NEWS

BDF Swap Systems:

New Support Beam!

For chassis with limited installation space

Art.-No. 411.610.181

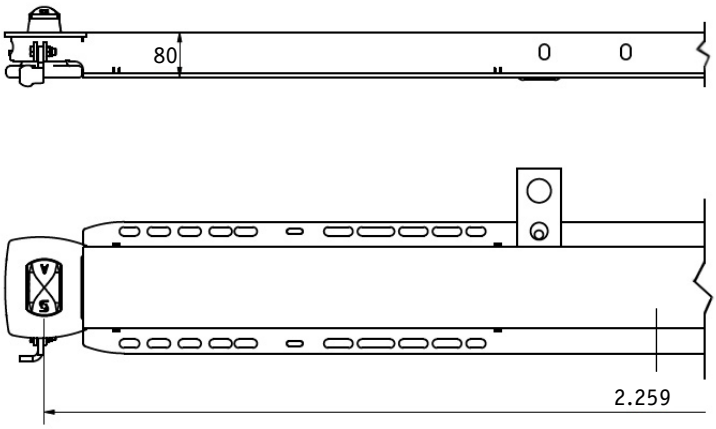
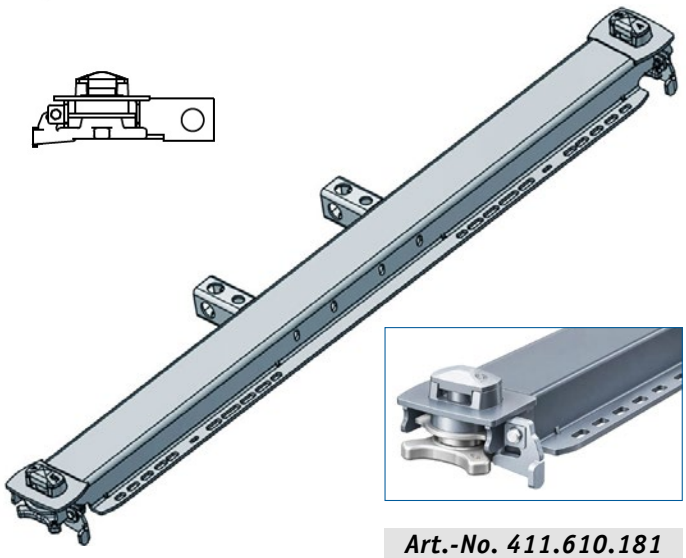
Some chassis, particularly those used for gas-powered and electric vehicles, provide only **limited space** for body installation. For the **WS Standard swap system, a newly developed, more compact support beam** is now available as an option.

- the rigid twist lock **eliminates the risk of contact with gas tanks or battery packs**
- **new cross-member** = less installation space
- **proven WS Standard** swap body system can now be fitted to a wider range of chassis without modification
- **reduced spare parts inventory** thanks to on standardised e.g clamping bolts and nuts
- **future-proof solution** for alternative drive systems or chassis with auxiliary units
